PLANNING COMMISSION

AGENDA

February 19, 2025

TO: Planning & Zoning Commission
FROM: Sarah McQuade, City Planner
DATE: February 19, 2025
RE: Harmony Phase 2C Final Plat Approval

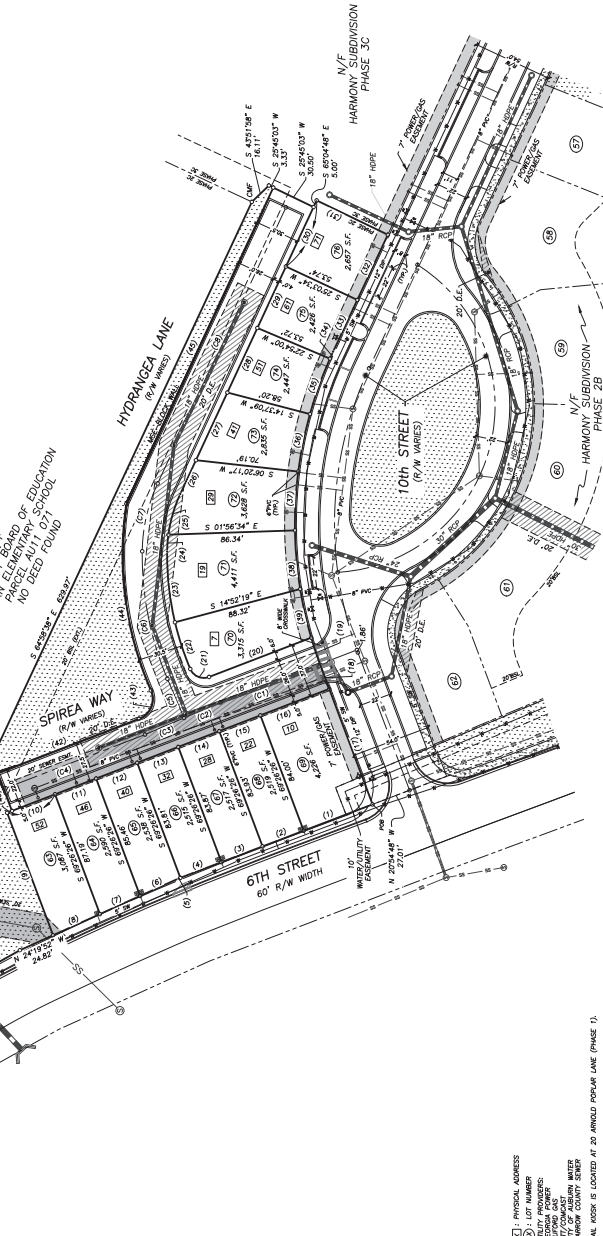
- *Sec. 16.20.070.A.16.xxi – The statement of final plat approval, pursuant to Sec. 16.20.070.A.19.iii, is not fully provided on the final plat. Several parts of it are missing.*

- *The final plat depicts a “phase 2C” phase line and label on a parcel that belongs to the Barrow County Board of Education, immediately north of the subject site.*

- *Engineering recommends that House Location Plans (HLP) be provided for proposed lots 71 and 72 prior to the issuance of a building permits on those parcels.*

1. The statement of final plat approval, pursuant to Sec. Sec. 16.20.070.A.19.iii, shall be provided on the final plat prior to submittal with the Barrow County Clerk of Court.
2. Phase lines shall be adjusted to most closely reflect said boundaries prior to submittal with the Barrow County Clerk of Court.
3. Platted lots 71 and 72 shall be labeled “HLP” to indicate the need for House Location Plans prior to submittal of the final plat to the Barrow County Clerk of Court.

KENTMERE

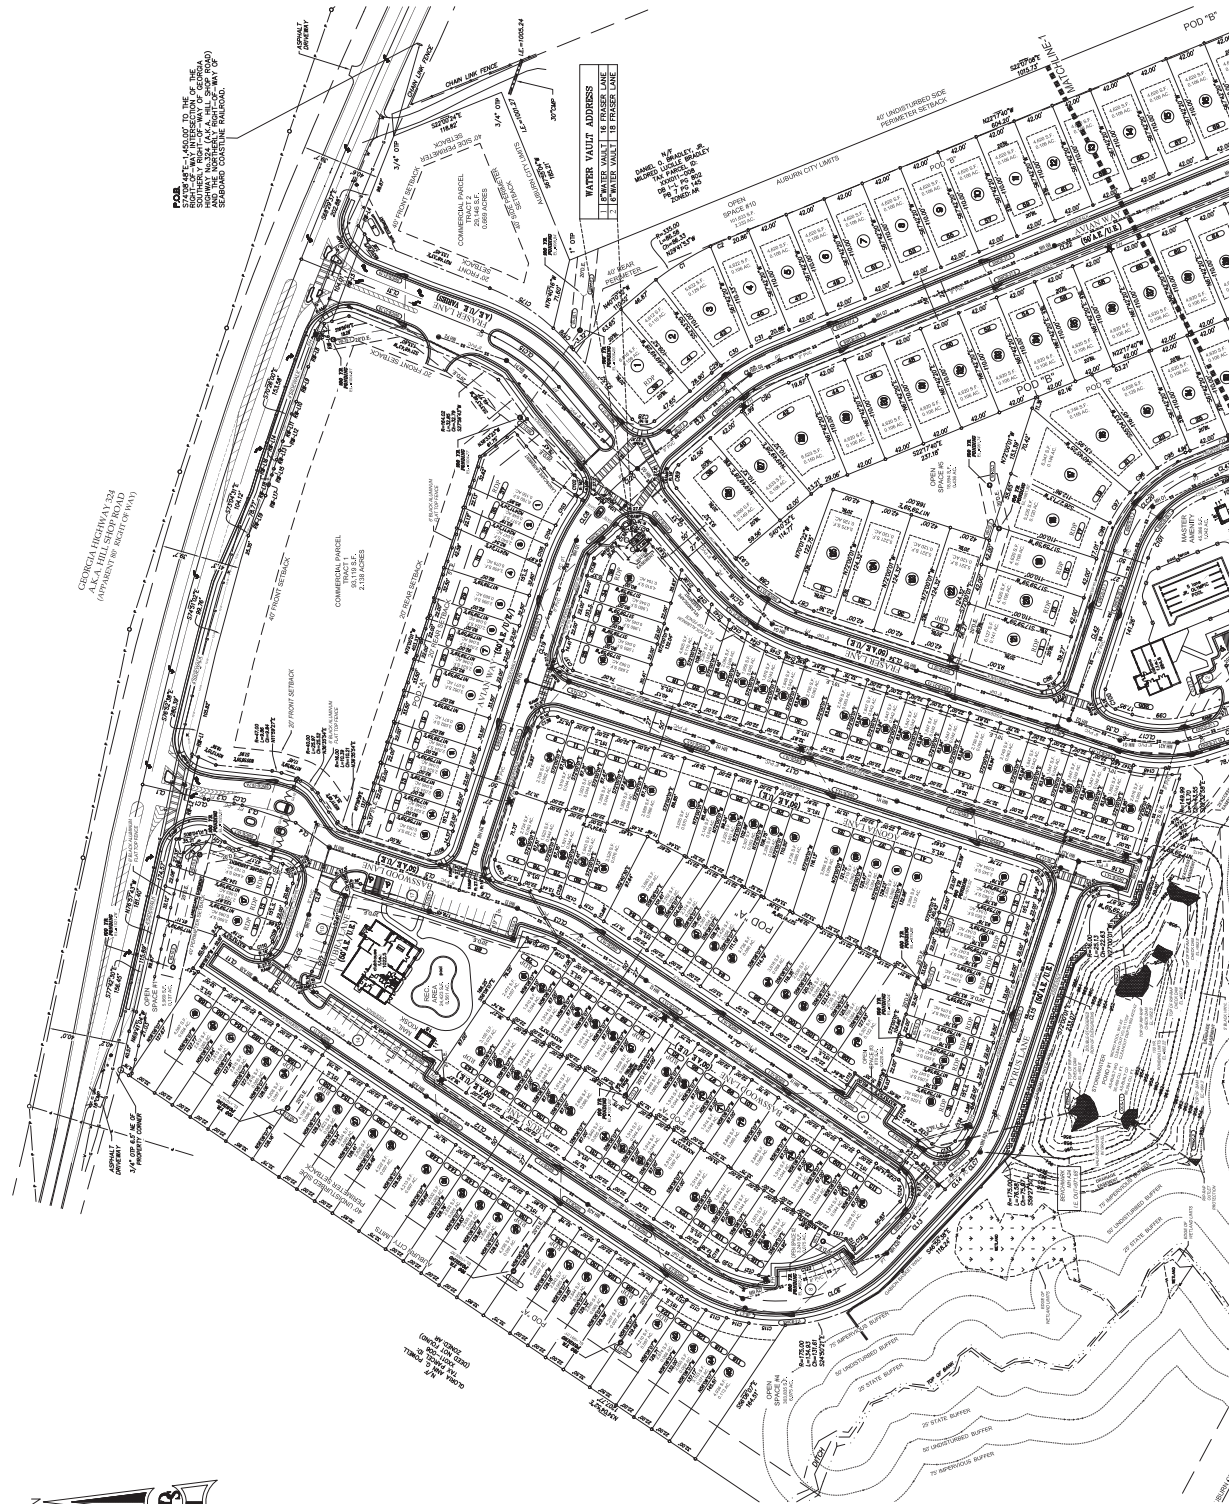
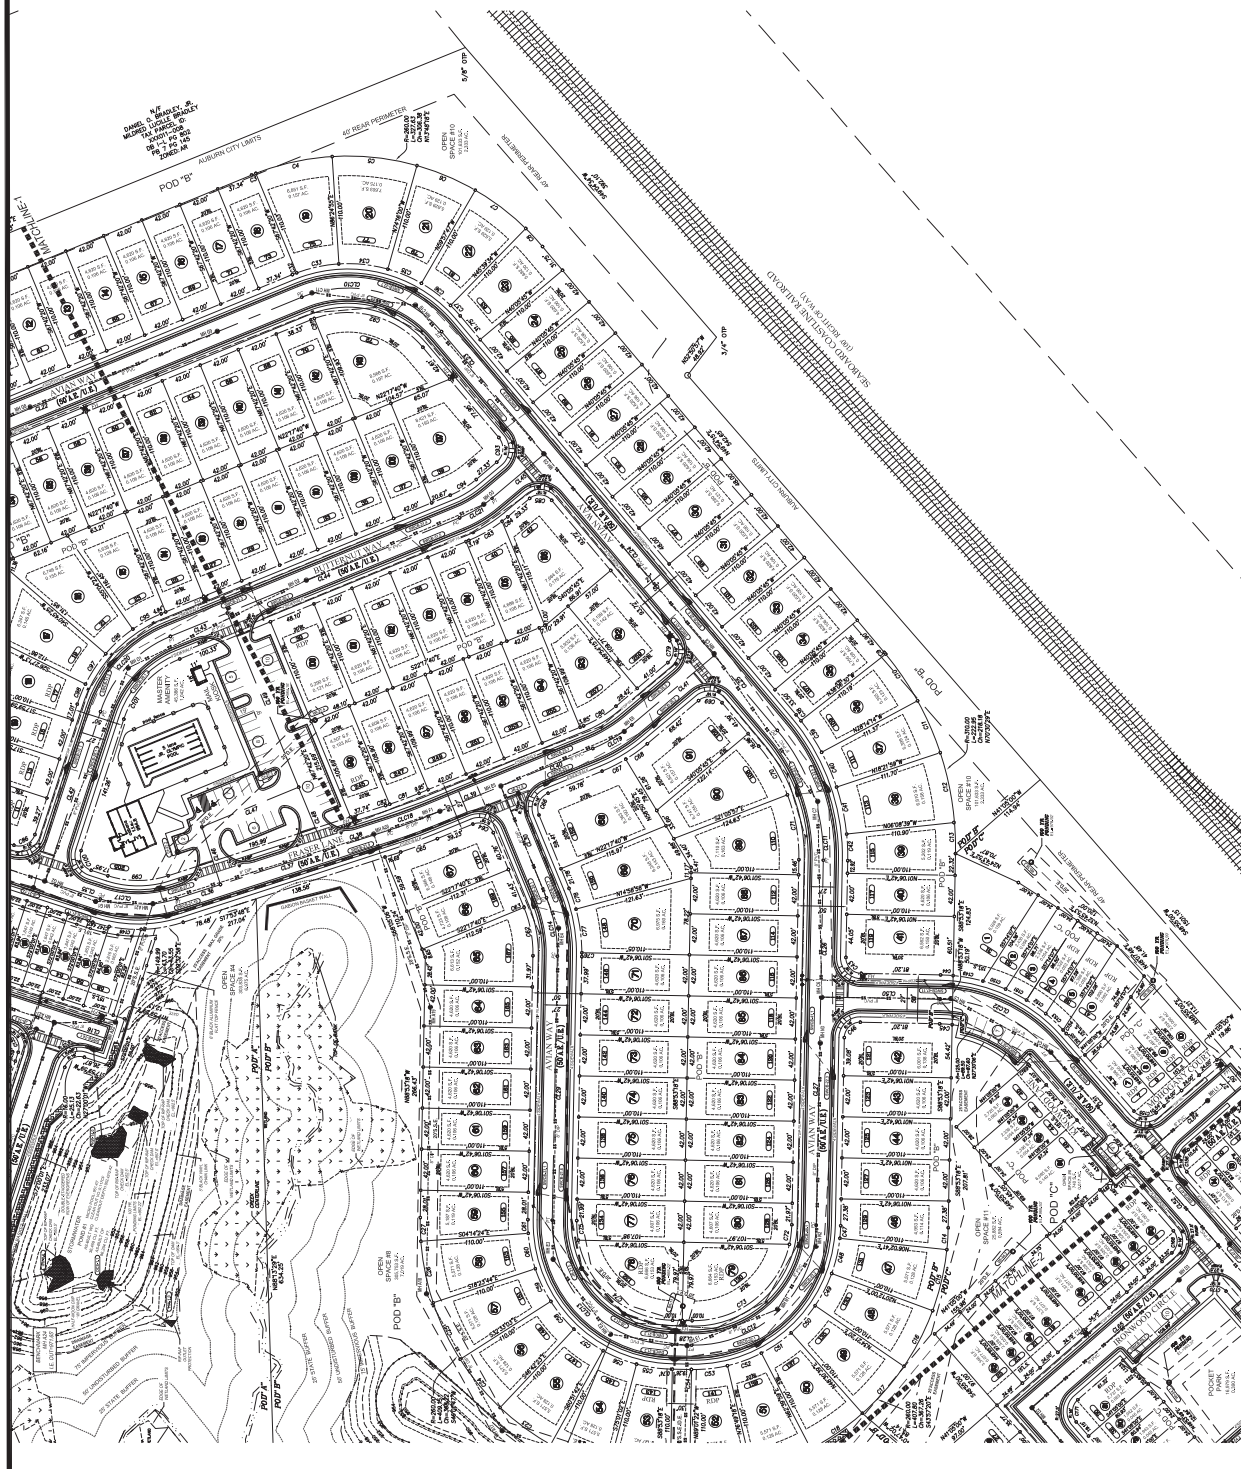
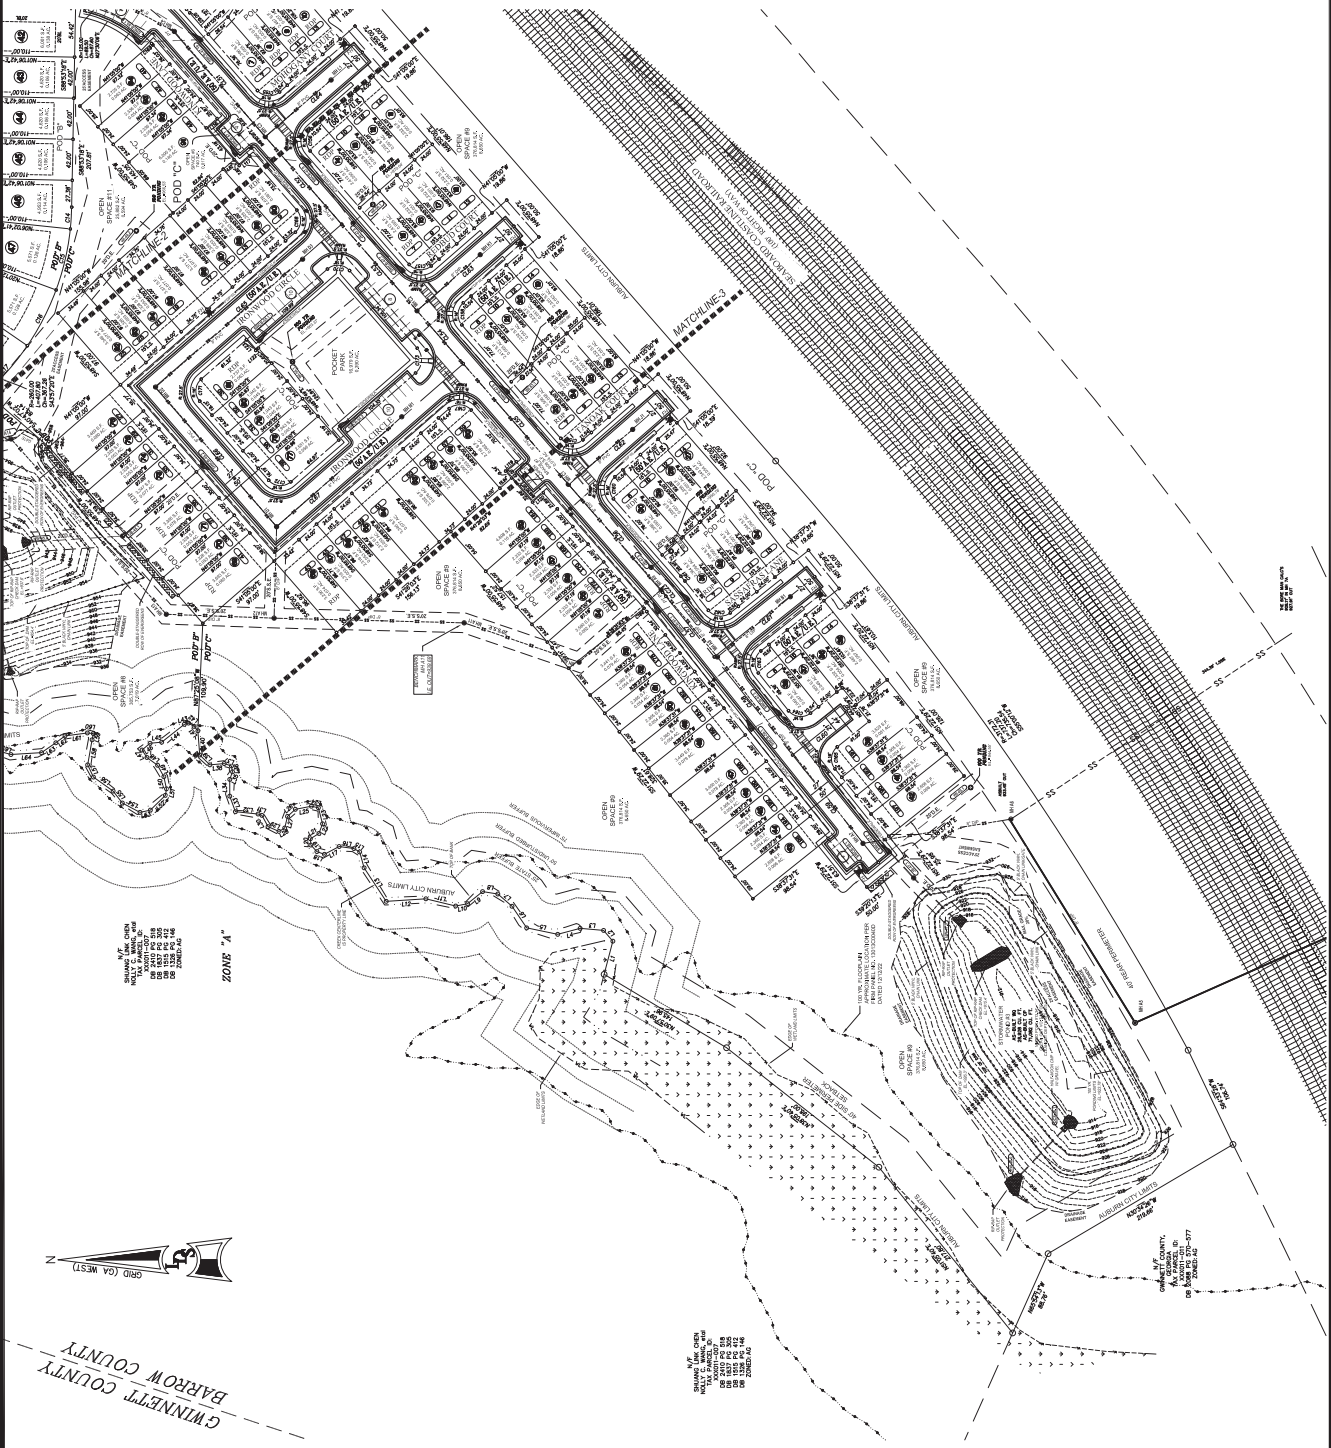
- *Sec. 16.20.070.A.16.x – The City Limits of Auburn are depicted on all sides of the assemblage, implying that the site does not abut any other parcels within the City. The land opposite of the railroad tracks is in the City; therefore, there is no City Limit abutting the railroad right-of-way.*

- *Sec. 16.20.070.A.16.xiv – Pursuant to Sec. 17.90.141.I.4, a landscape strip no less than 15 feet in depth is required along all internal streets. In some instances (i.e. platted lots 124 through 144), a 10-foot landscape strip is provided, which does not meet the 15-foot minimum. In other cases (i.e. northwest sides of platted lots 22 and 23) the landscape strip depth is not specified along the abutting internal street.*

- *Sec. 16.20.070.A.16.xvii – The land area (coverage) of each proposed stormwater pond is not specified.*
 - *Sec. 16.20.070.A.16.xxi – The final plat approval statement, pursuant to Sec. 16.20.070.A.19.iii, provides the year as "2024". Furthermore, the first portion of the statement is missing.*

- *Staff has reviewed the final plat for compliance with zoning conditions, and has found the following inconsistencies.*
 - *Site development condition #4 – It is unclear if the Homeowners Association will*

provide for townhome building maintenance, repair, insurance, and working capital.

- *Site development condition #8 – Not all residences adjacent to stormwater detention facilities are screened by double staggered rows of evergreens (i.e. platted lots 53 through 56).*
- *The Area table on the cover sheet does not account for 100-year floodplains, wetland areas, sidewalks under 8 feet wide, or stormwater facilities. These features cannot count as open space or common area ([Sec. 16.24.090](#) and [Sec. 17.90.141.I.2](#)).*
- *General Note 17 on the cover page states that the zoning designation of the site is “CS”, which is correctly contradicted by General Note 3.*
- *On-street and amenity area parking calculations have not been provided.*

1. The City Limits of Auburn shall be modified on the final plat for accuracy prior to submittal with the Barrow County Clerk of Court.
2. All platted parcels shall be shown with a landscape strip no less than 15 feet in width along all internal streets prior to submittal with the Barrow County Clerk of Court.

3. All stormwater ponds proposed within the platted area shall be accompanied by a note specifying their surface areas prior to submittal with the Barrow County Clerk of Court.

4. The statement of final plat approval, pursuant to Sec. Sec. 16.20.070.A.19.iii, shall be provided on the final plat prior to submittal with the Barrow County Clerk of Court.

5. The City Planner or their designee shall review the Kentmere covenants and restrictions for compliance with site development condition #4 prior to submittal with the Barrow County Clerk of Court.

6. Full compliance with site development condition #8 shall be depicted on the final plat prior to submittal with the Barrow County Clerk of Court.
7. An accurate portrayal of areas that cannot be considered open space or common area, pursuant to [Sec. 16.24.090](#) and [Sec. 17.90.141.I.2](#), shall be included on the cover sheet of the final plat prior to submittal with the Barrow County Clerk of Court.

8. General Note 17 on the final plat cover sheet shall be amended or removed so that the area zoning designation is not misrepresented prior to submittal with the Barrow County Clerk of Court.

9. On-street and amenity parking calculations shall be provided on the final plat prior to submittal with the Barrow County Clerk of Court.

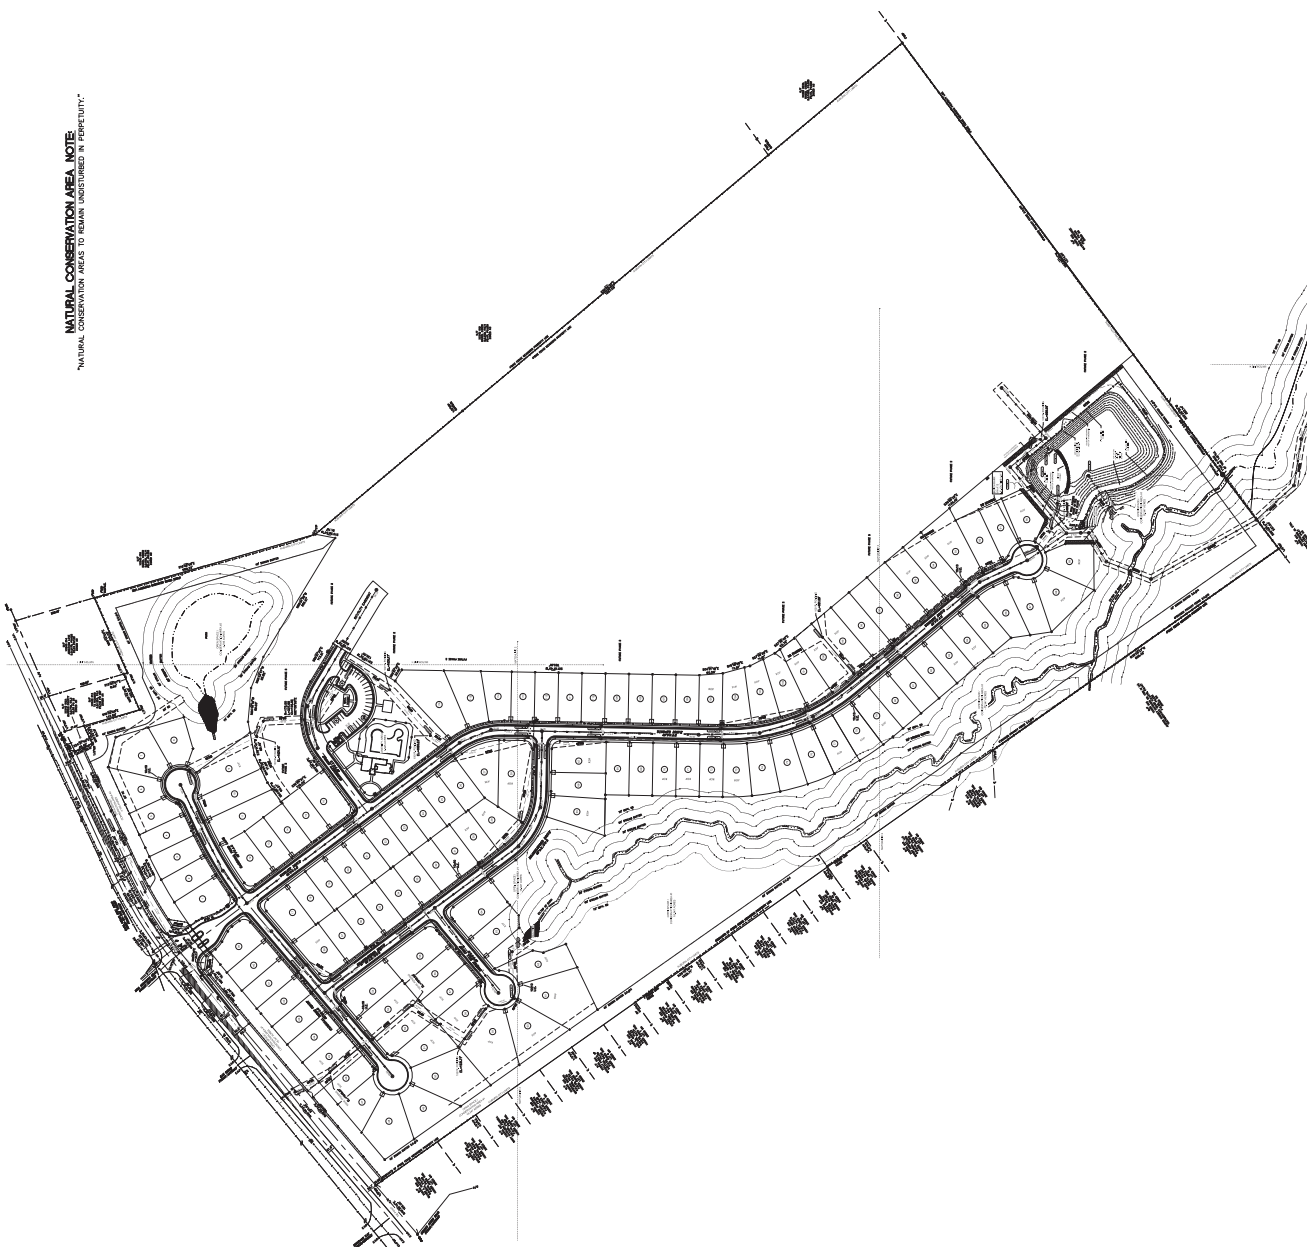
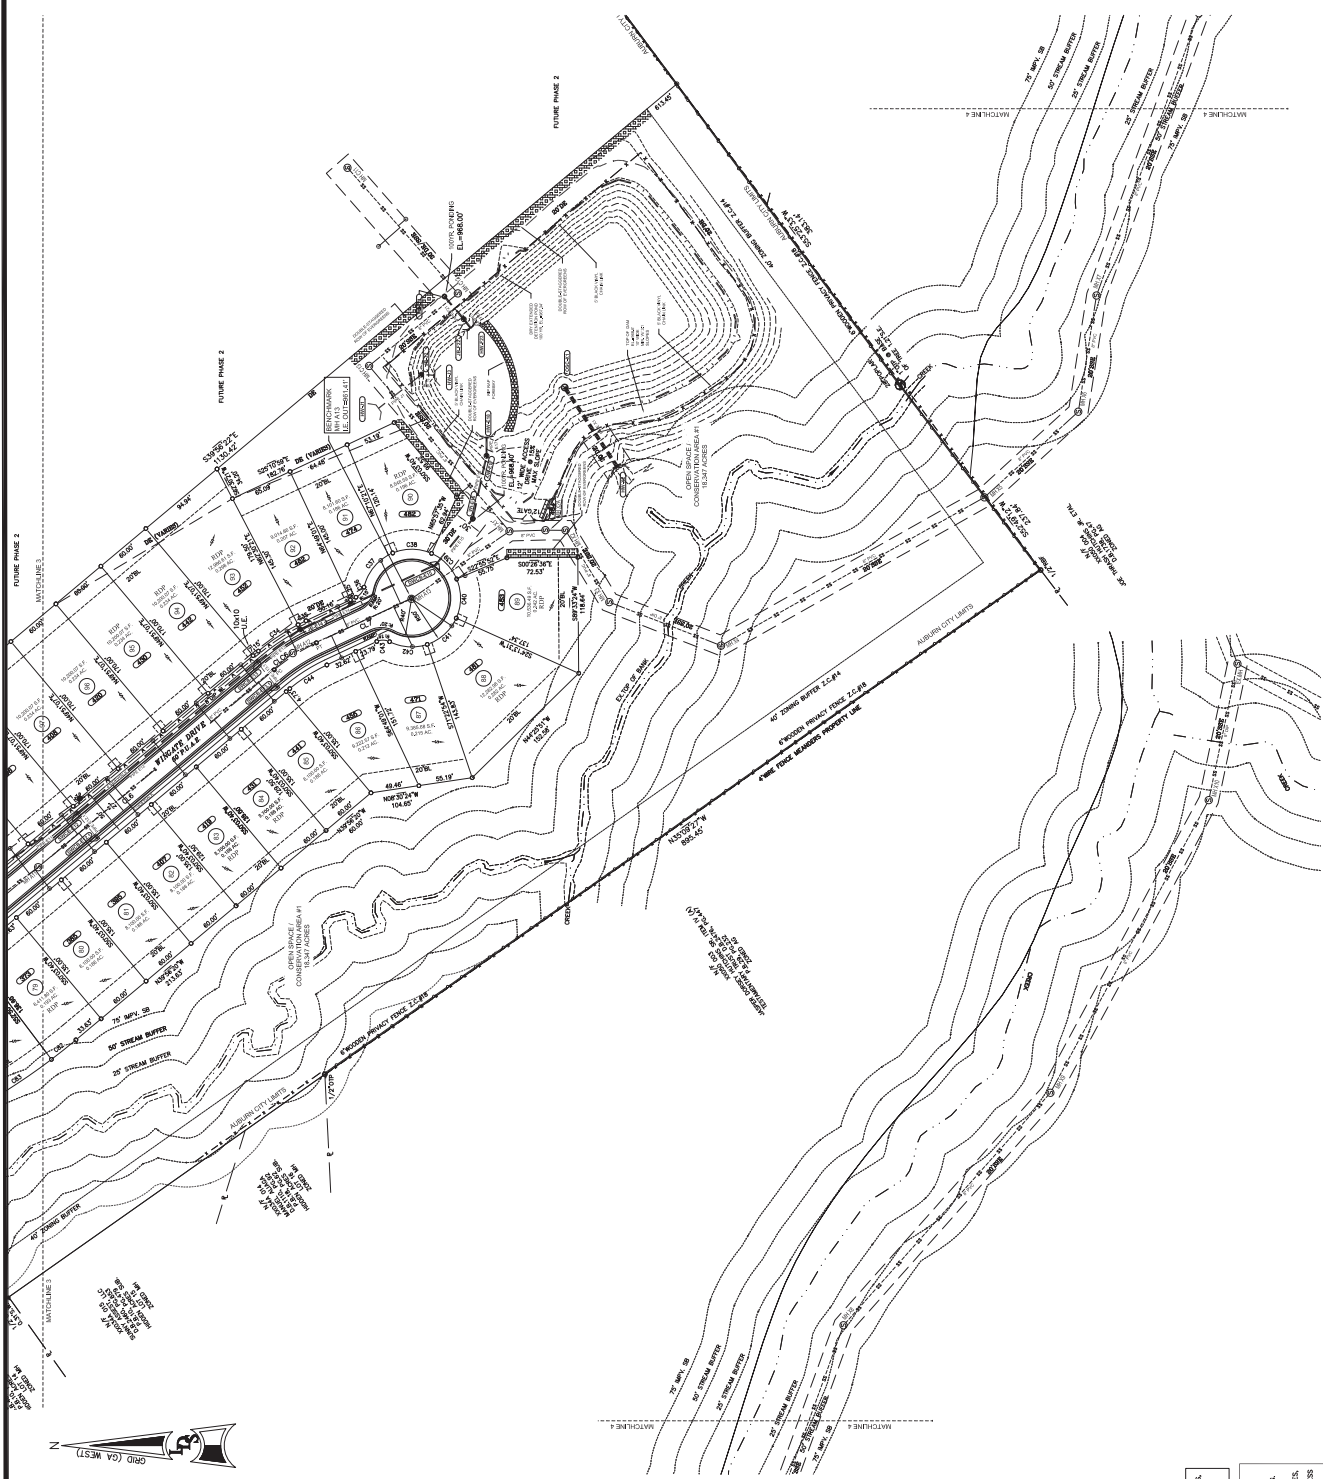
- *Condition #13 – several building lots encroach upon 75-foot impervious stream buffer (i.e. rear of lots 70 through 73).*
 - *The Area table on the cover sheet does not account for 100-year floodplains, wetland areas, sidewalks under 8 feet wide, or stormwater facilities. These features cannot count as open space or common area ([Sec. 16.24.090](#) and [Sec. 17.90.141.I.2](#)).*

1. The statement of final plat approval, pursuant to Sec. Sec. 16.20.070.A.19.iii, shall be provided on the final plat prior to submittal with the Barrow County Clerk of Court.
2. A note shall be added to the final plat stating that: "No improvement shall be permitted in the 75-foot impervious stream buffer for lots: 63, 65, 70, 71, 72, 73, 77, 78, 79, 83, 84, 88, and 89.
3. An accurate portrayal of areas that cannot be considered open space or common area, pursuant to [Sec. 16.24.090](#) and [Sec. 17.90.141.I.2](#), shall be included on the cover sheet of the final plat prior to submittal with the Barrow County Clerk of Court.
